**TOWN OF PORTOLA VALLEY
ARCHITECTURAL AND SITE CONTROL COMMISSION (ASCC)
Monday, January 14, 2013
Special Field Meeting (time and place as listed herein)
7:30 PM – Regular ASCC Meeting
Historic Schoolhouse
765 Portola Road, Portola Valley, CA 94028**

TO: ASCC
FROM: Tom Vlasic, Town Planner
DATE: January 10, 2013
RE: Agenda for January 14, 2013 ASCC Meeting

Image 1a – view from Alhambra with new trees shown

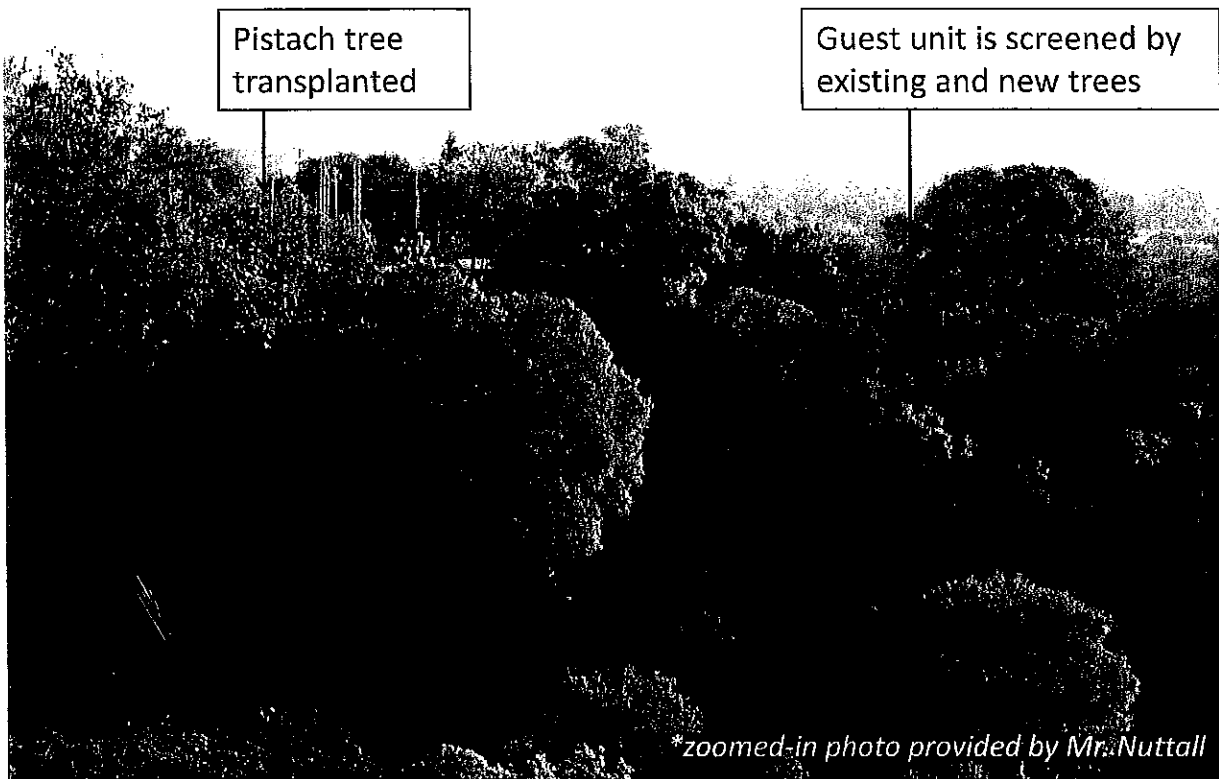
- The ridge line is below the tree line when seen from Alhambra.
 - Our windows are predominantly to the views to the south (where no neighbors are in sight).

Image 3a – west balcony redesign

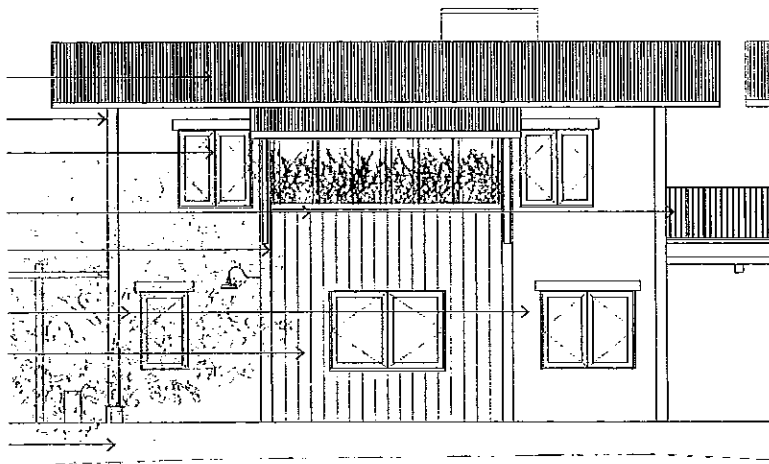
3. We have redesigned the west-side balcony to address privacy issues and soften its appearance. The picketed guardrail has been replaced with an opaque segment with an inset planter box, and plantings shroud the remaining opening. The roof overhangs as well, blocking views to and from higher points. See Image 3a.

1. Picketed guardrail is now opaque.
2. Planter box added which reduces visible area on balcony.
3. Plantings shield the remaining opening.
4. With overhanging roof and plantings, the light spill and the views to/from neighbors have been minimized.

Image 3b – west balcony redesign

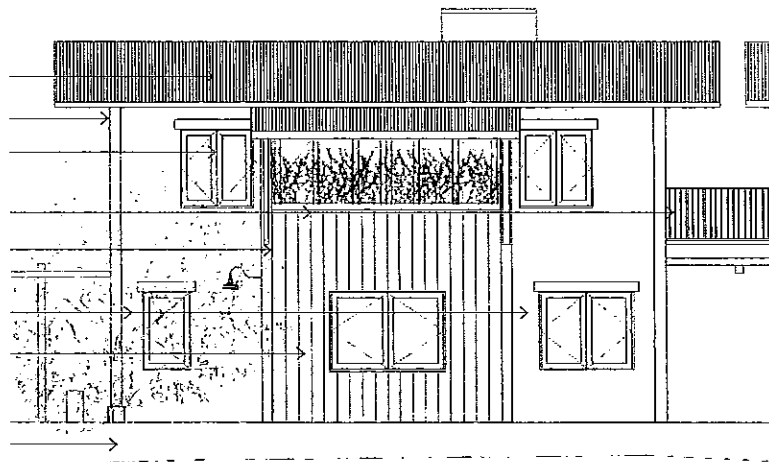
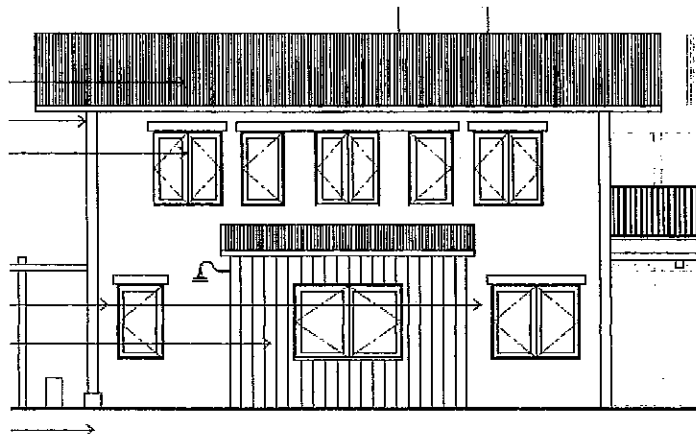
4. Removing the balcony eliminates options for screening these windows. See Image 3b.

Removing the balcony creates more light spill and eliminates possibility of screening these windows.
